UNITED STATES PATENT AND TRADEMARK OFFICE
CERTIFICATE OF CORRECTION

PATENT NO. : 6,896,818 B2
APPLICATION NO. : 10/650187
DATED : May 24, 2005
INVENTOR(S) : Perry et al.

(54) **WATER FILTRATION AND RECYCLING
FOR STONE FABRICATION EQUIPMENT**

Fig. 1; Fig. 2; Fig. 3A; Fig. 3B are replaced with the attached sheets consisting of Figs. 1-3B.

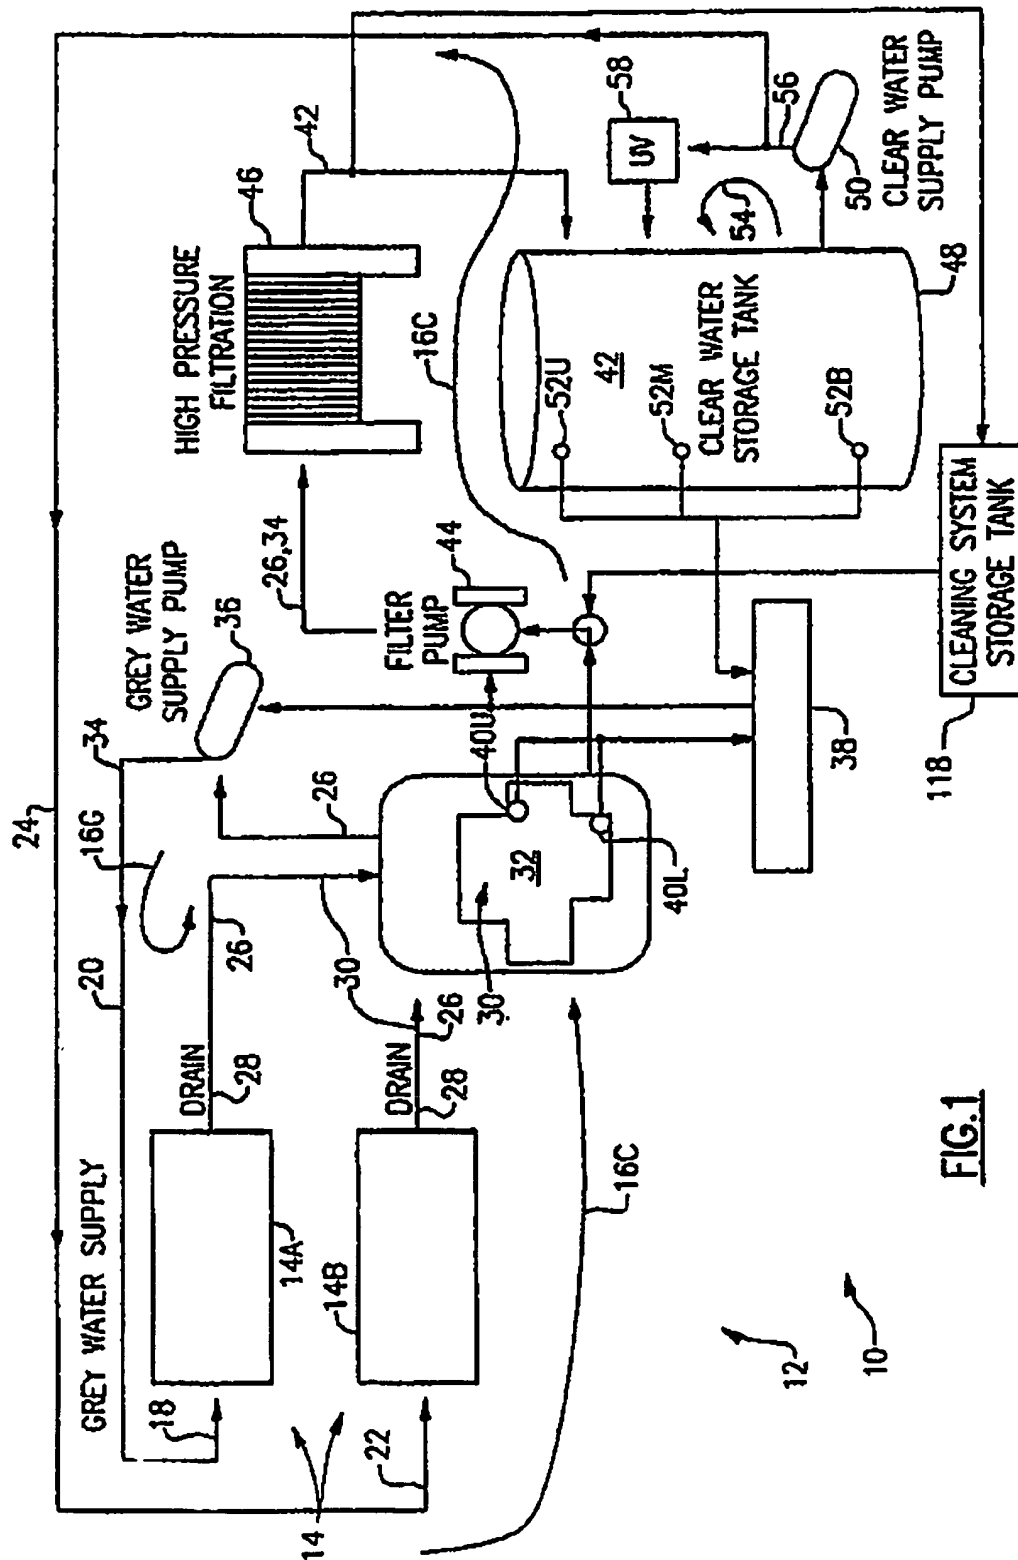
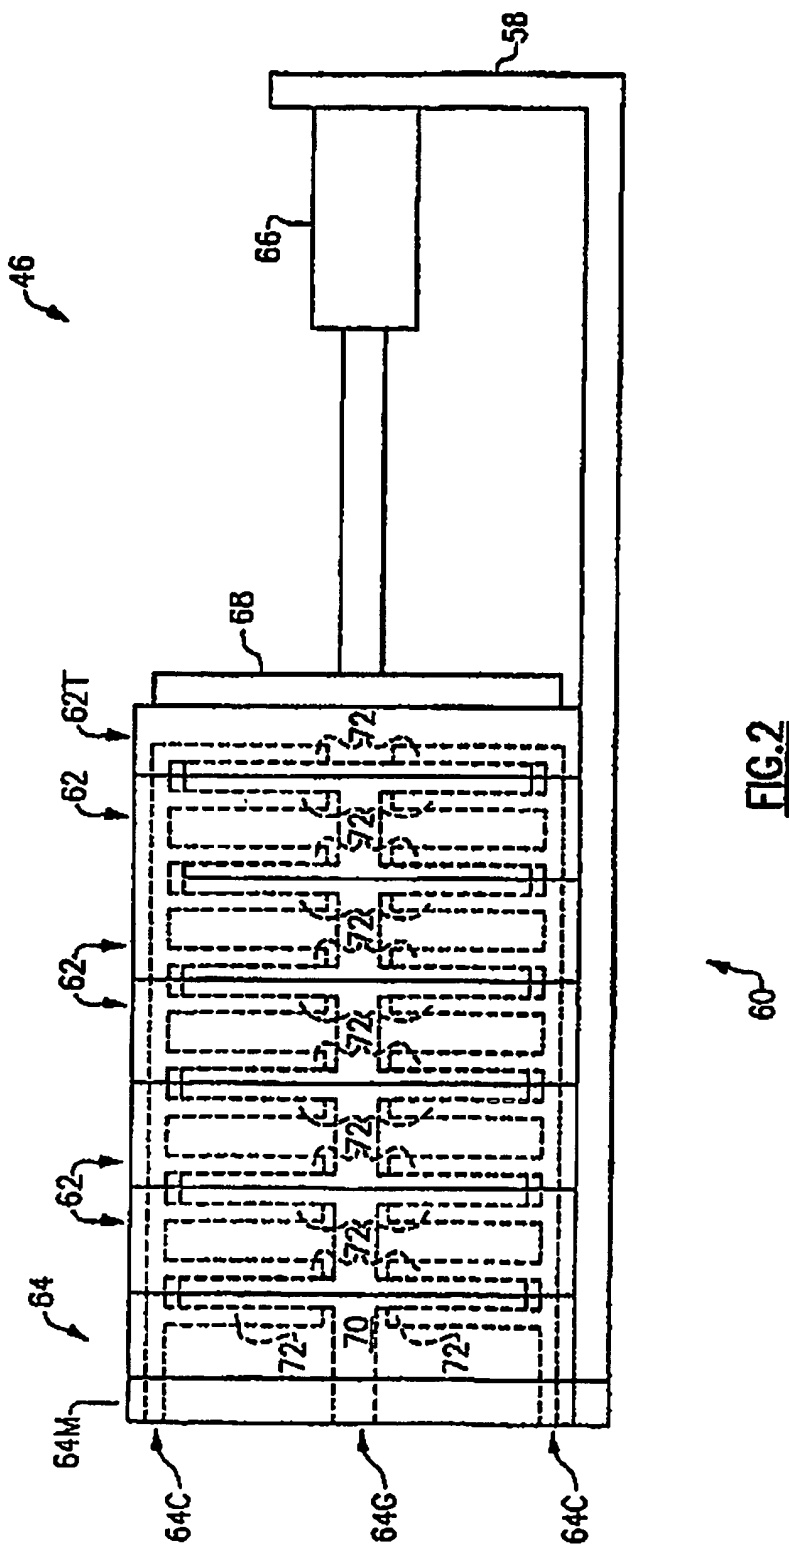
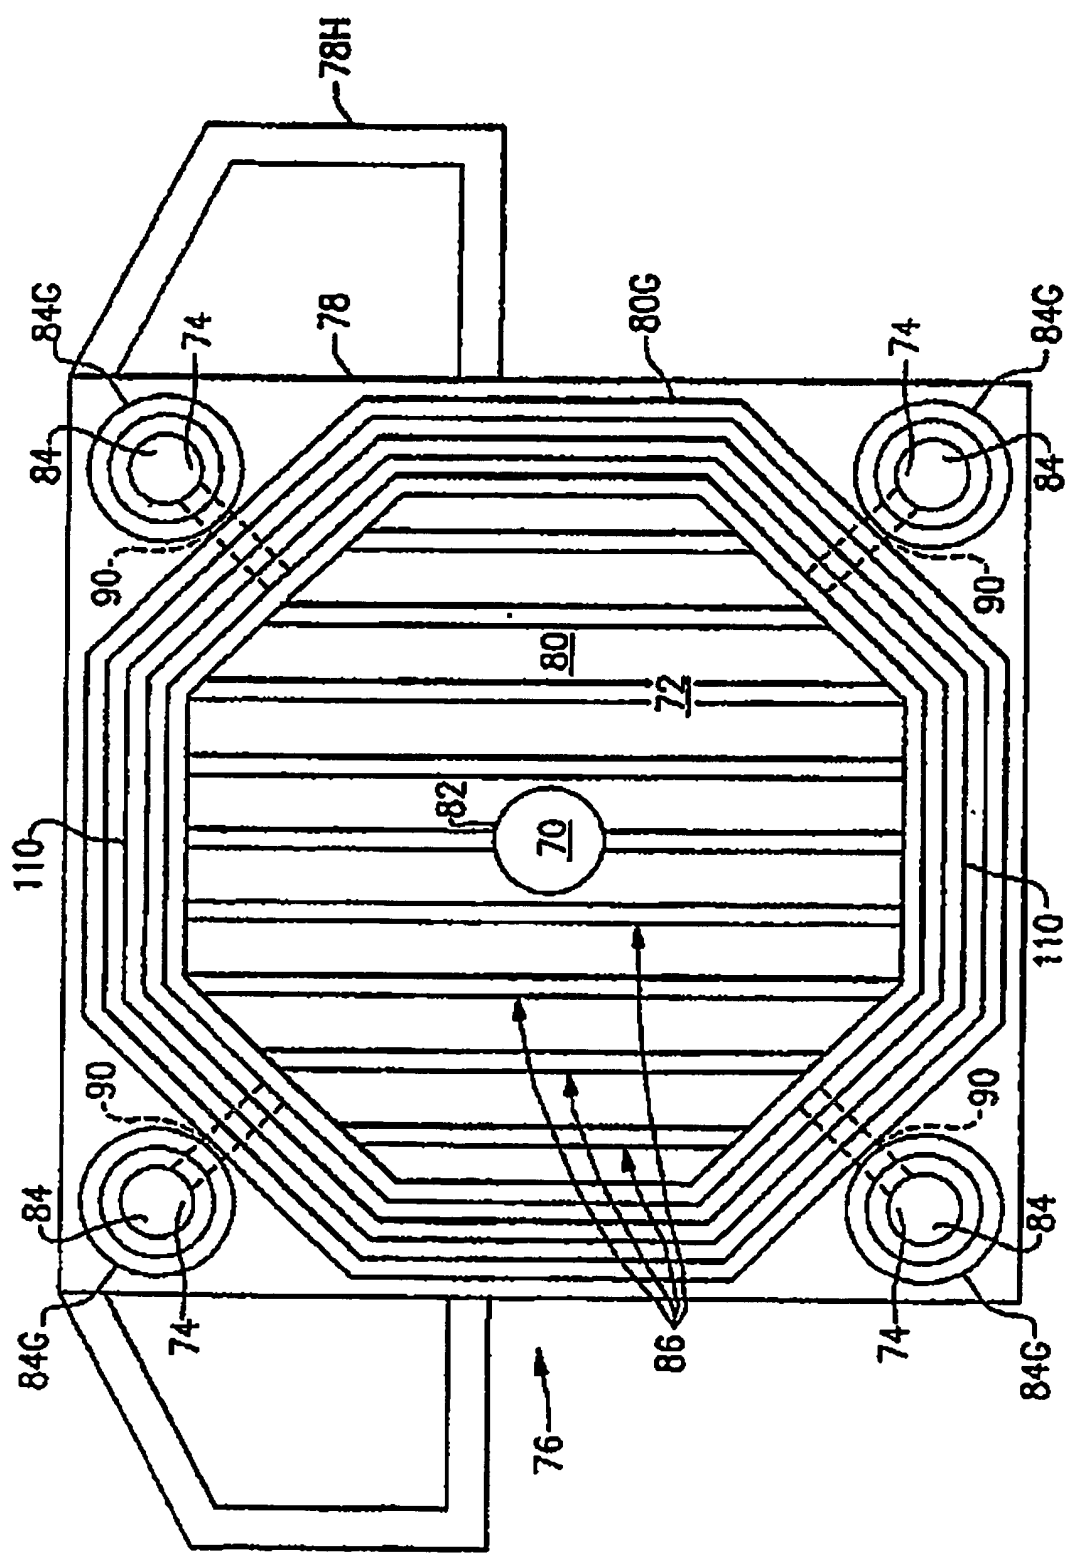
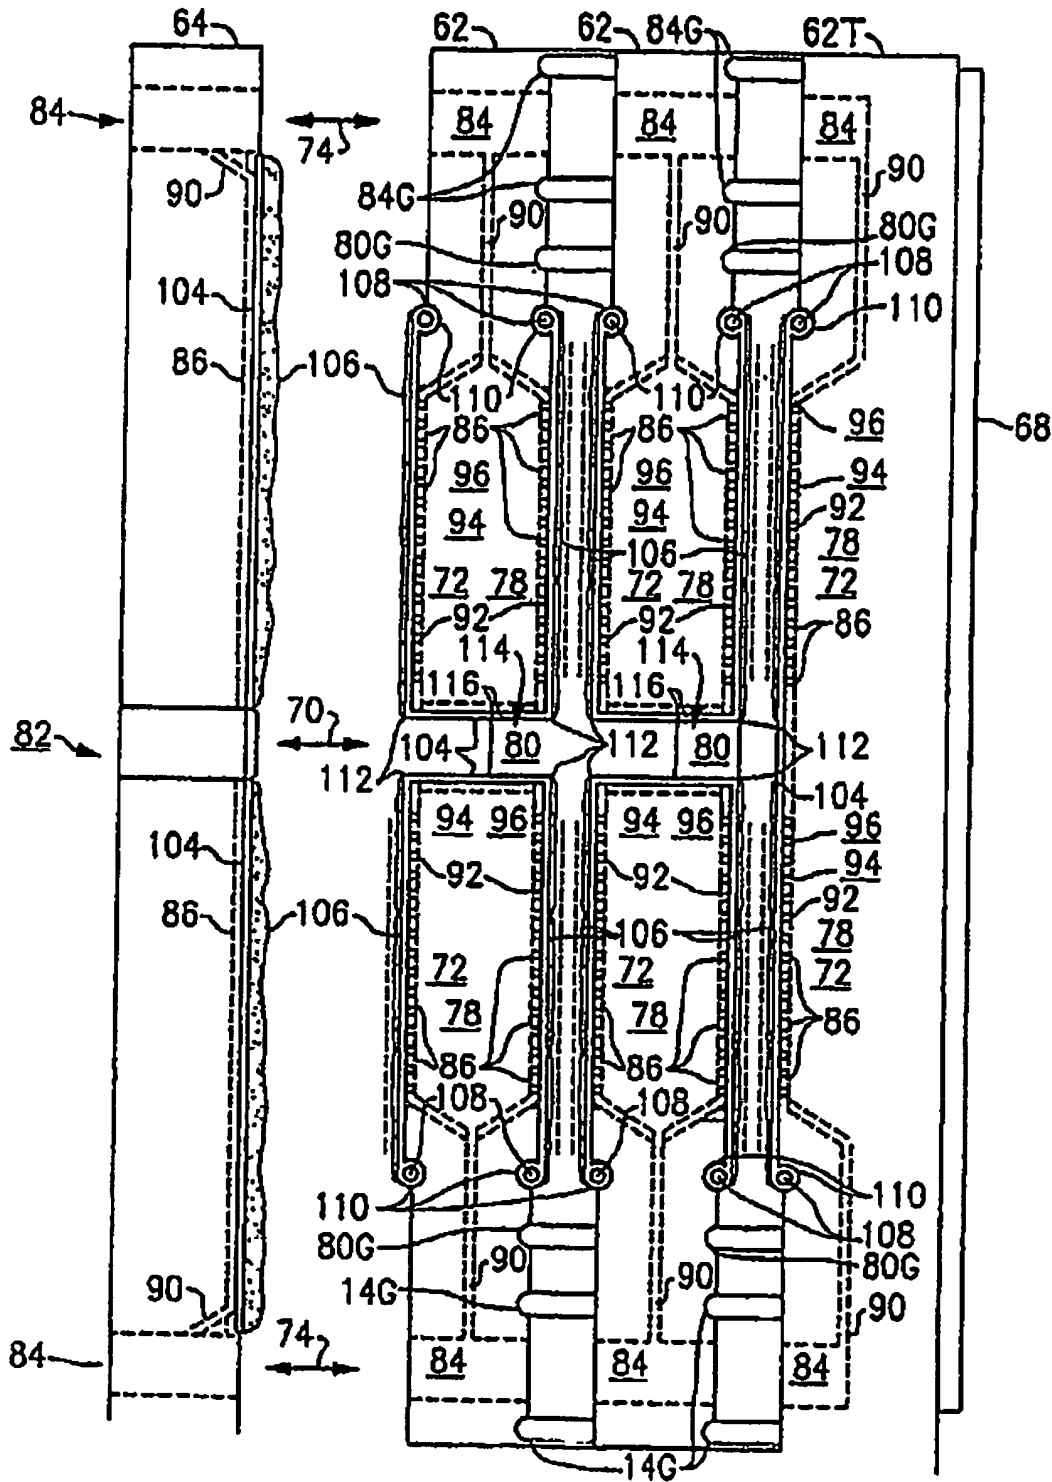
On The Title Page and sheets 1-4
